Commission of Architectural Review SUBMISSION APPLICATION

LOCATION OF WORK: 2109 and 2111 M St DATE: 3/27/15

Proposed changes to 2109 and 2111 M Street:

Right Elevation

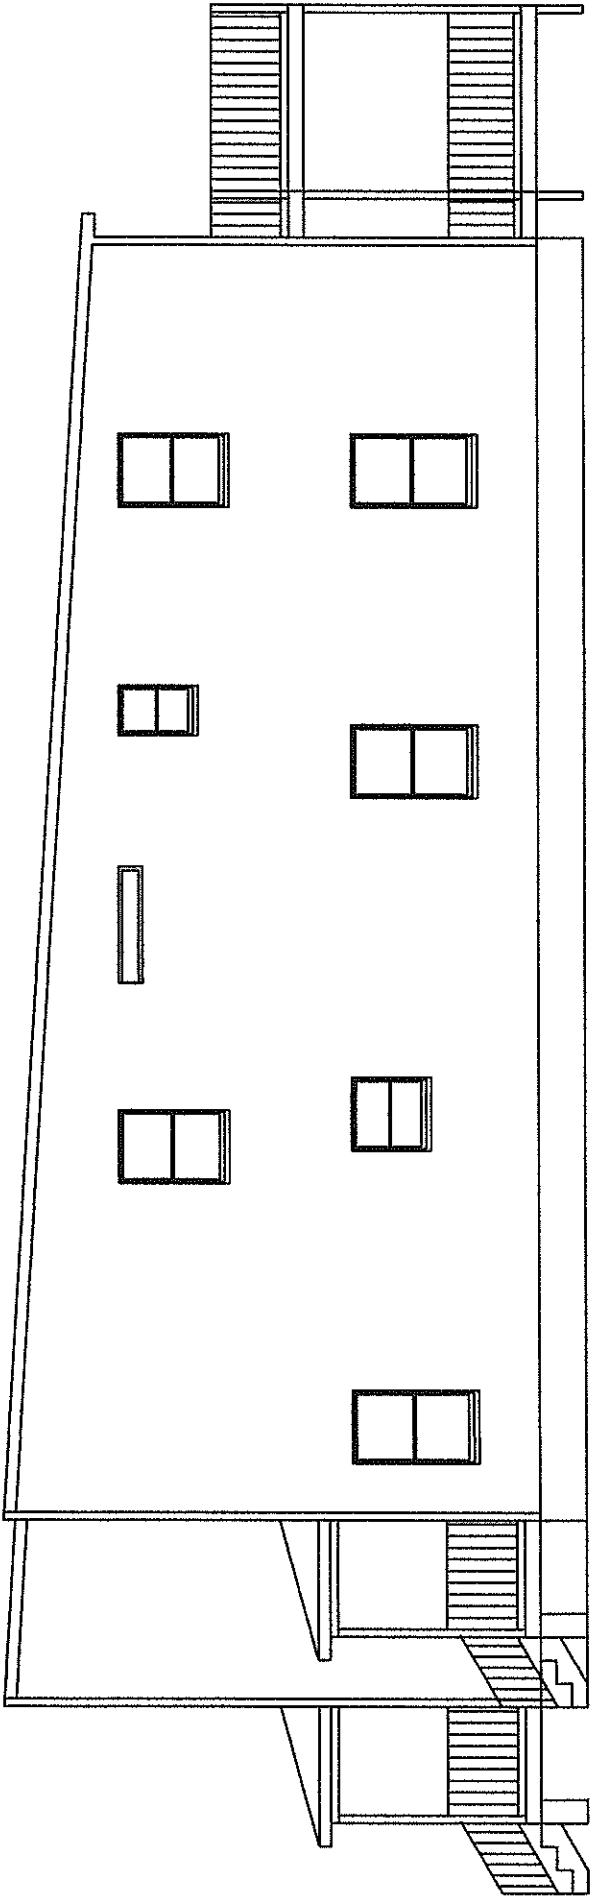
2 – Slight changes to window locations on side views

Rear Elevation

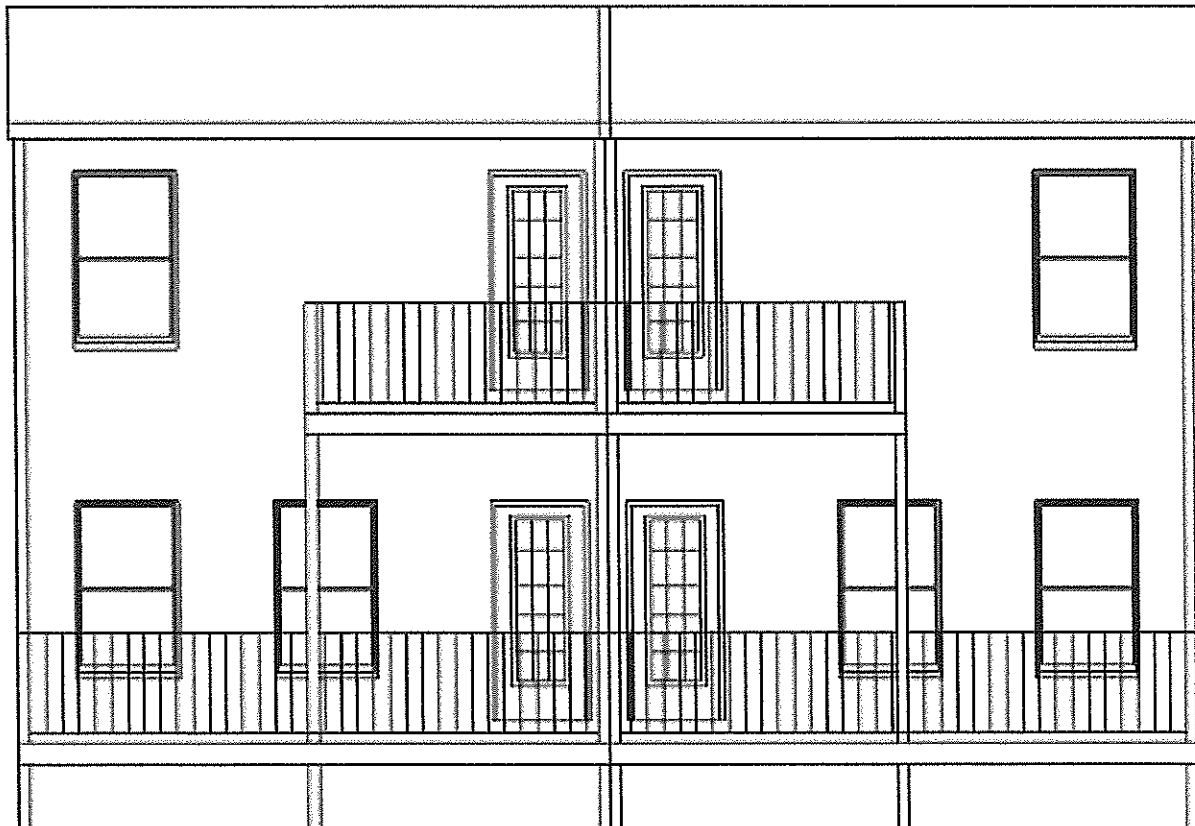
1 - Reduce second floor decks to 10' x 9' from the previously approved 10' x 18'
